As many of you know, I've been investigating the claims of both the SFHA and FOS experts at the request of a wide range of property owners. This investigation has led to the discovery of weaknesses in all the plans that were on the table as of mid October. Some of these defects led to inaccurate projections and fundamental design flaws that could be extremely costly. After seeing my latest report, which follows, a number of property owners from both sides of the pond asked me to share it with everybody concerned by the debate.

The first part covers Haley and Aldrich's responses to a series of questions during a conference call with me on Friday, Nov. 21, 2014.

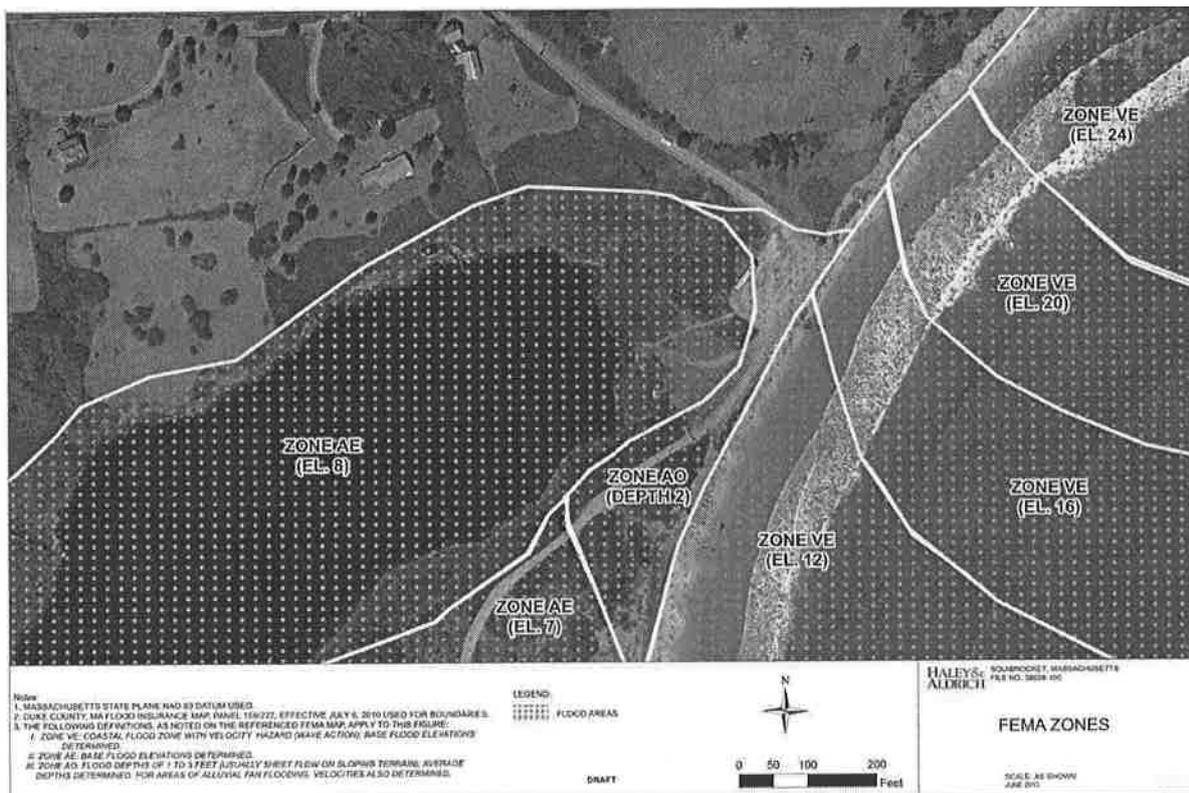
A) They will now recommend moving the southern (Money Hill) anchor point from "92 ft" to "115 ft" from their old benchmark at the "shoreline". This would put the new anchor point directly under the "NE AO" of Zone AO" on the following FEMA flood

map (Figure 10 of H&A's July 22, 2014 document), according to them. It was unclear how this new point relates to today's effective high tide mark or bank edge, which I've had drawn on the Google Earth photo above item C, since they also said that the revised anchor point would be "118 ft from the bank", but, if the point is just below the "NE AO", then Google Earth indicates that the new "safer" anchor point would only be about 70 feet from the normal effective high water mark (as indicated by the blue arc connecting the change in color between the wet and dry sand to the south of the parking lot to the equivalent line between the lower and upper beach to the north) and less from the bank.

* The first yellow line to the right/east.

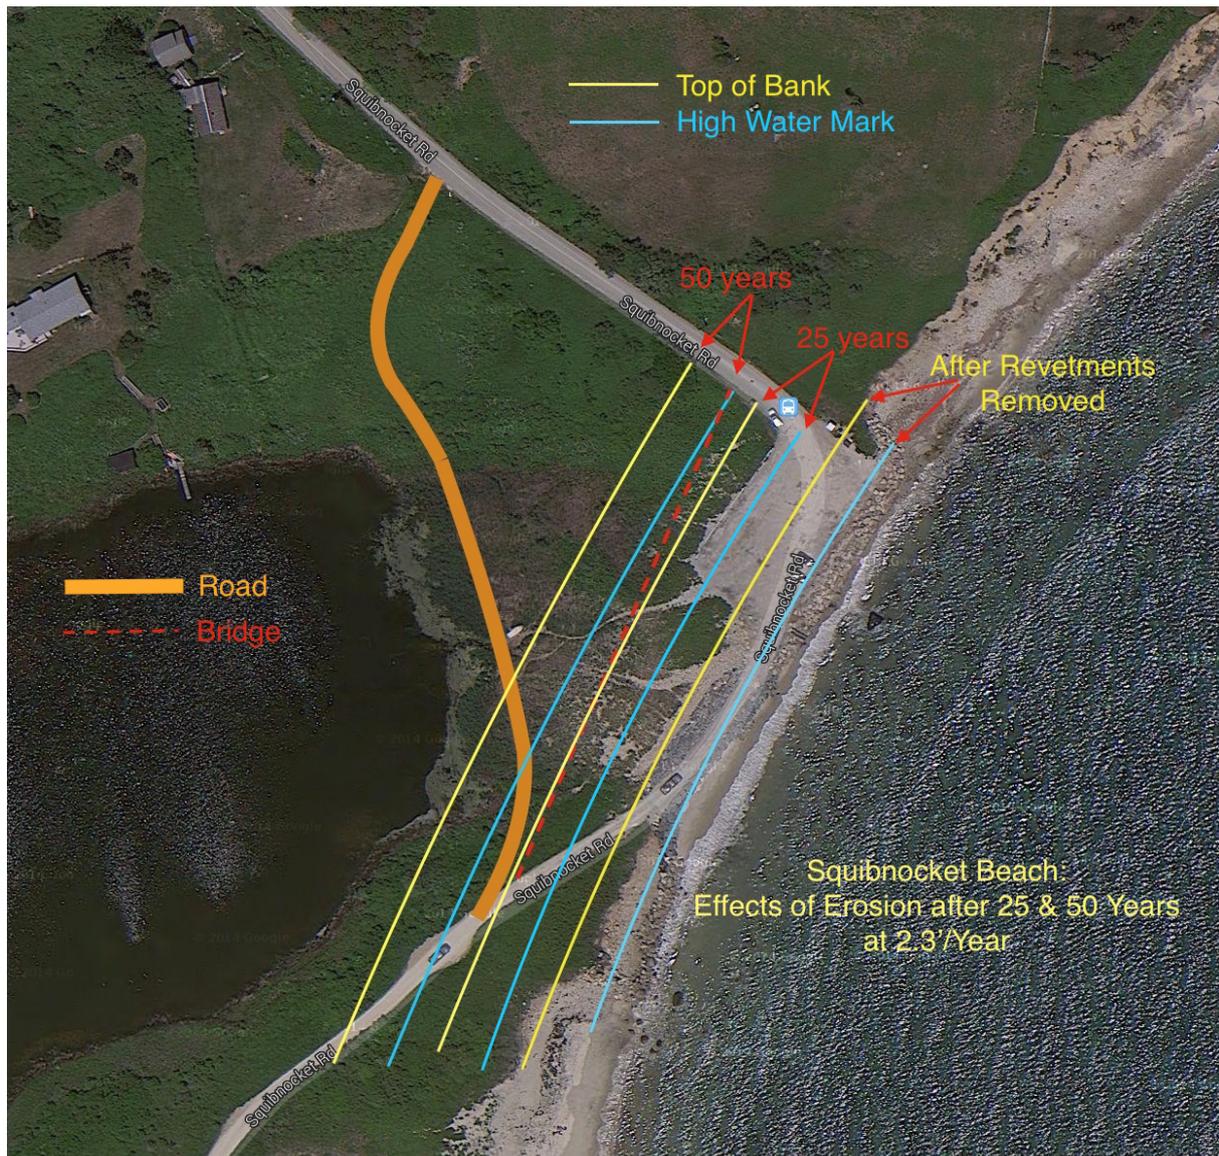
B) H&A will also move the northern anchor point from "150 ft" to "170 ft" back from today's "shoreline", although H&A has now agreed that their "shoreline" benchmark is not particularly meaningful. When I pressed them to define the new position in relation to the arc* formed between the present banks, where the bluff will stabilize soon after the revetments are removed (if they are removed), they said the new point would be "132 ft" back from it. As I mentioned, it would be nice to receive H&A's revised map, so I can calculate independent numbers both from the mean high water mark and bank edge.

In the meantime, I must assume that the numbers you'll find in **Part 2** are more accurate. These indicate that the distance between the line where the bank edge is likely to stabilize and Peter Weldon's land is really just 100 ft. It would obviously be considerably less to the bridge's northern anchor point.

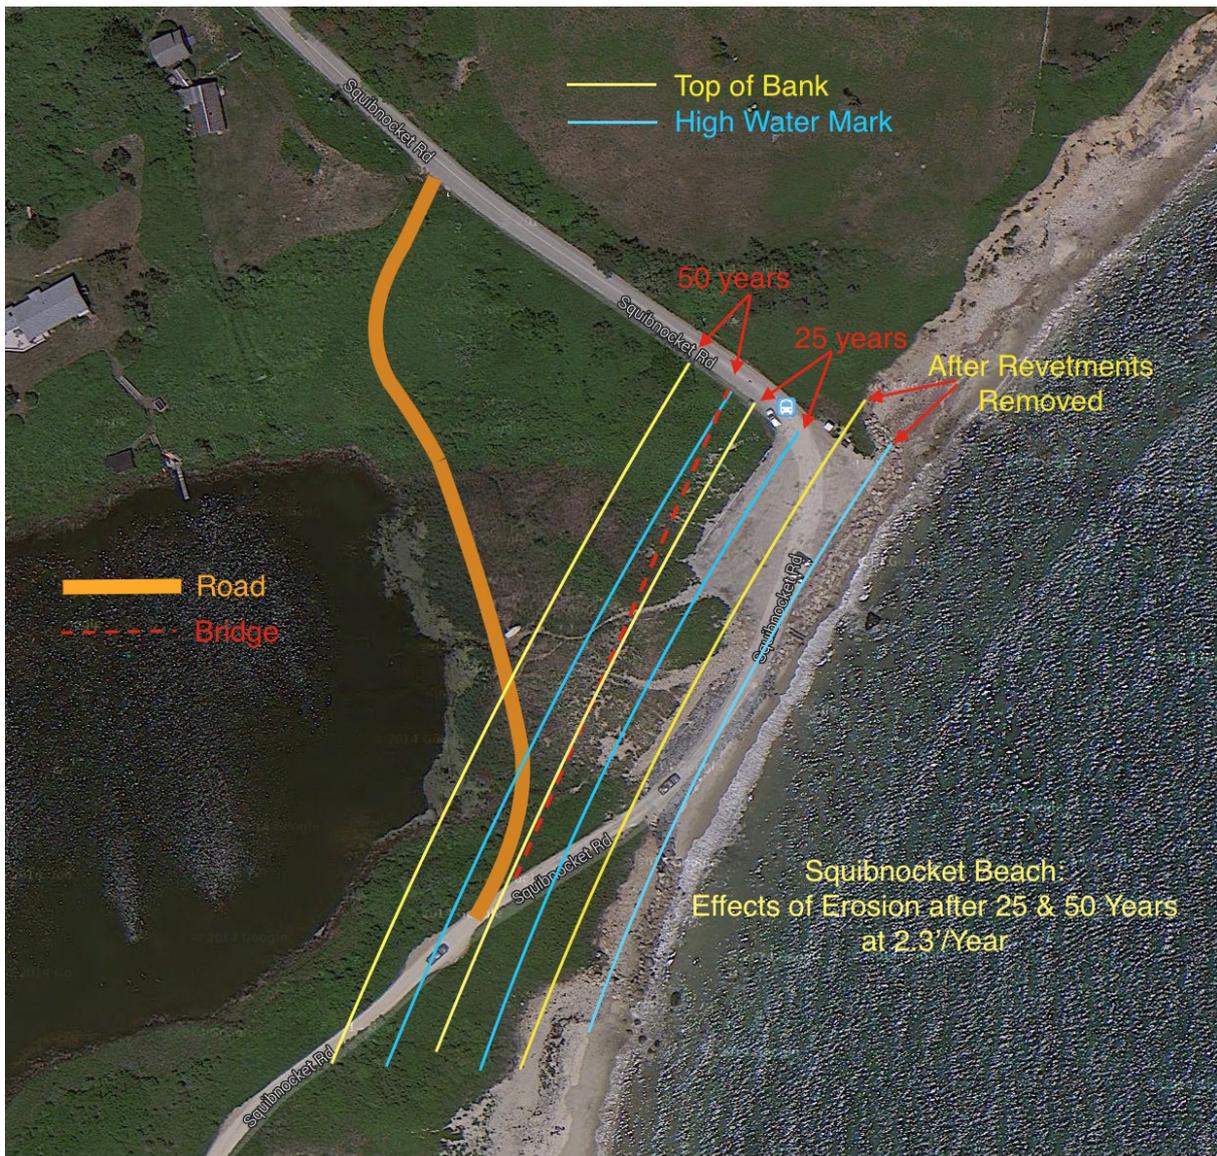
As you'll see in the above Google Earth photo taken on a medium tide, the average effective high tide mark is clearly visible as a change in coloration of the beach (because of wet vs. dry sand, changed sorting forces on beach stones, and lines of sea wrack) both to the north and south of the parking lot. The first blue arc on the right (in other words, to the east) connects these indicators of the normal daily

Neither team of engineers had taken these clear changes in beach coloration as their departure points for placing their initial arc, which, in at least one case (FOS's), was actually oblique to the water, with its southern end at or below the low tide mark. The consequence of these new observations is that we have a much more accurate departure point for calculating the recession of the effective high tide line to the northwest at a highly conservative rate of 2.3 feet per year for 25 and 50 years from now.

The other rectification concerns the departure point for the edge of the bank, which is essential to know, since an elevated causeway will be stranded once the bluff edge recedes past its anchor points, which will happen long before the effective high water mark reaches them. My first yellow arc to the right (the east) connects the current edges of the banks at either end of the parking lot to show the crescent where the bank will stabilize immediately after the removal of the revetment (if it is indeed removed), say in 2016. This new departure point allows us to make a conservative 2.3 foot annualized recession calculation for the bank edge in 25 and 50 years.

The middle pair of blue and yellow lines shows where the high tide and bank edges will be under a best-case scenario, if the revetments are removed, in 25 years. As you can see, the southern (Money Hill) end of the bridge (as proposed by H&A until our conference call), which is indicated by a dotted red line, will be between the bluff and high water mark ***within that period.***

The final pair of yellow and blue lines to the left (the west) show the best-case scenario in 50 years. As you can see, the northern anchor point for the bridge (as proposed until the call) will be stranded by the recession of the bluff edge in about 35 years (under the most optimistic scenario), and will be at the effective high tide mark within 50 years.

Finally, I have shown FOS's latest iteration of the proposed road, whose grades seem acceptable under today's regulations for accessing residential neighborhoods, as an orange line. It is important to understand that this road will be a dynamic changing feature, while the trestle bridge will be an inflexible fixed one, because the southern end of the road will actually migrate to the northwest, out of the danger zone, as the pond edge there also moves in that direction due to eutrophication, overwash, and, perhaps most importantly (although nobody seems to have emphasized it), erosion from the roadbed itself, which could be topped off annually to fill ruts and potholes like dirt roads all over the Vineyard.

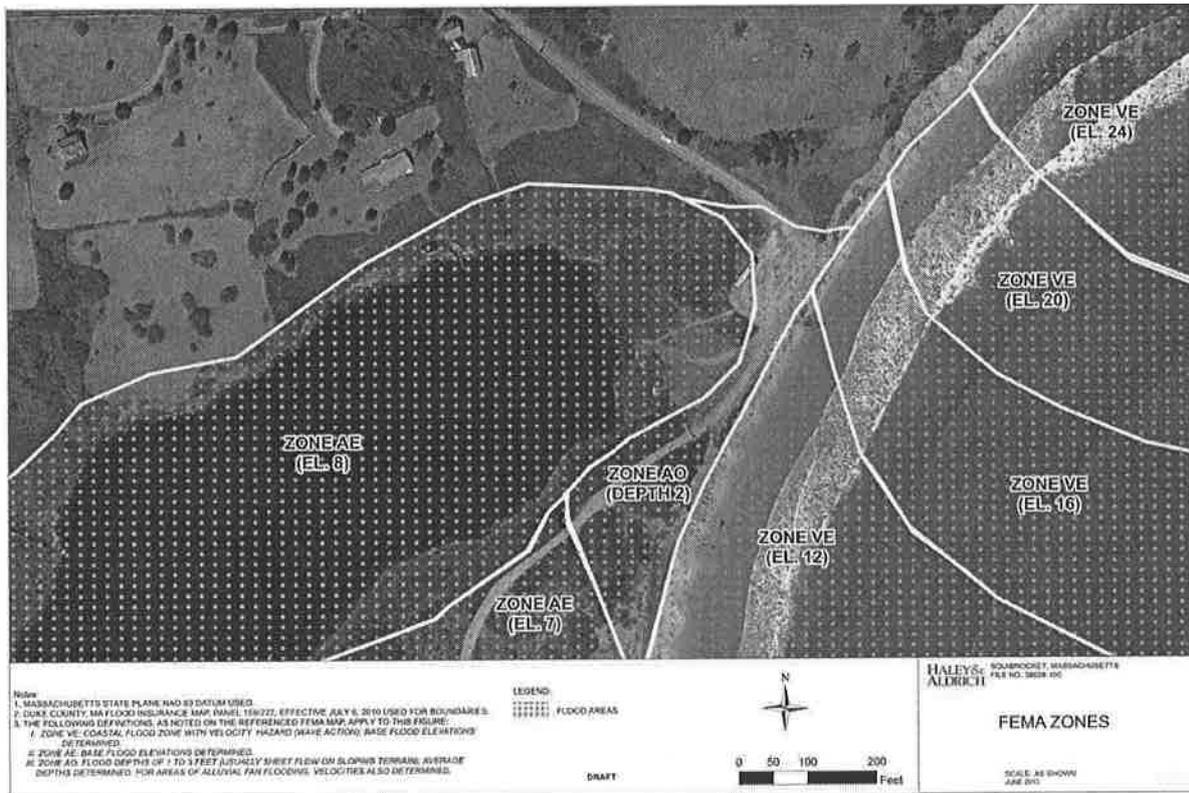
Lastly, I want to return to the implications of figure 10 in H&A's report of July 22, 2014. As we've seen, it shows the projected flooding around the Squibnocket parking lot during a "100 year storm" as of 2010, rather than in the future. The flood zone amounts to a 400+ foot-long breach into Squibnocket Pond and looks at first glance like an excellent argument for a bridge of *at least* 450 feet!

1) The first thing to note is that the Money Hill (southern) anchor point for the bridge would be inundated under at least 2 feet of water **even now** in such a tempest - let alone in 15 to 25 years with incremental erosion (not to mention sea level rise or southwestern creep). If the flooding was also accompanied by currents and erosion (as it would be), the anchor point could even be **lost** today according to figure 10.

2) The northern anchor point for the bridge could also be flooded in such a contemporary event, and, once again, if the flooding involved currents, it could be **lost**.

3) The triangle at bottom center, which includes the road on the barrier beach, would be inundated during a storm, but would bounce back afterwards and survive the breach! What makes this so fascinating is that the artificial dune system is not only meant to extend that resistant triangle to the northeast but to do so in an even more survivable form because of its higher elevation. The fact that the existing barrier beach and dune extension would also begin acting as a single integrated system, which would move westward into the pond, and could be topped off when needed, just adds a silver lining.
